W217602600 INSTALL NOTICE

Kits packed before January 11, 2017 have an install manual diagram showing to clamp the lower bracket assembly around both the primary leaf stack and the overload spring (if so equipped) (Figure 1)

Figure 2

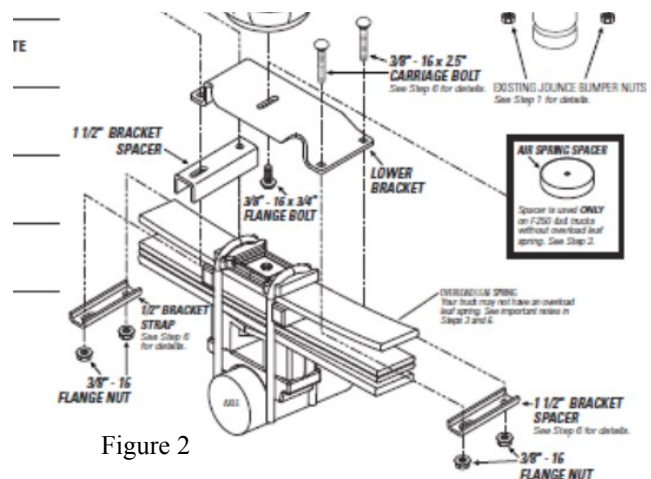
Firestone has since updated the manual to reflect clamping the lower bracket directly onto the overload spring, as shown in Figures 2 and 3.

Figure 4, showing incorrect install. The lower clamp should be under the overload (top spring) only, not under the primary leaf stack.

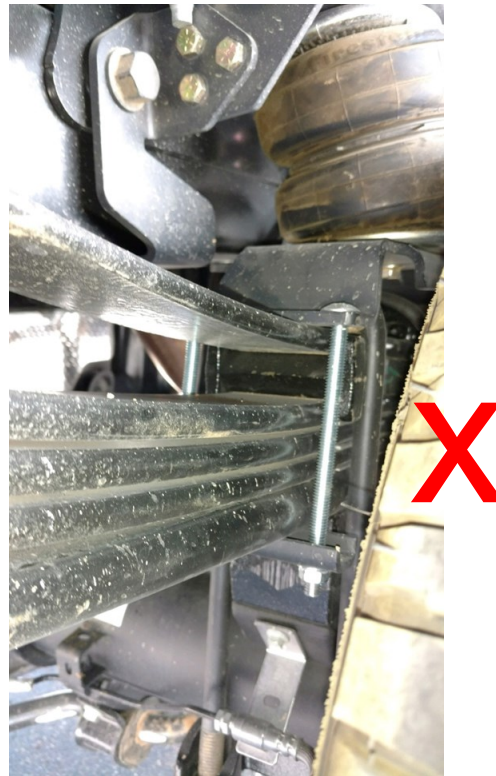
If you have sold or installed a kit packed prior to January 11, 2017, you should inspect the installation to ensure it looks like Figure 3, with the lower clamp attached directly to the overload, and not like shown in Figure 4 (below). If you have installed a kit with the lower bracket clamp and bolts around both the primary leaf stack and the overload, as shown in Figure 4, contact us at rrtech@fsip.com or at 317 818 8600 extension 1 and 1 for warranty, and Firestone will send at no additional charge replacement short bolts and new nuts to clamp onto the overload only.

Please be advised that when the vehicle is equipped with an overload spring, the lower bracket assembly should be clamped onto the **OVERLOAD ONLY**, as shown in Figure 3. Failure to do so could, on rare occasions and under extreme loads, allow the lower bracket assembly to slide forward on the leaf stack resulting in lower air spring lifting force and possible contact between the upper and lower brackets.
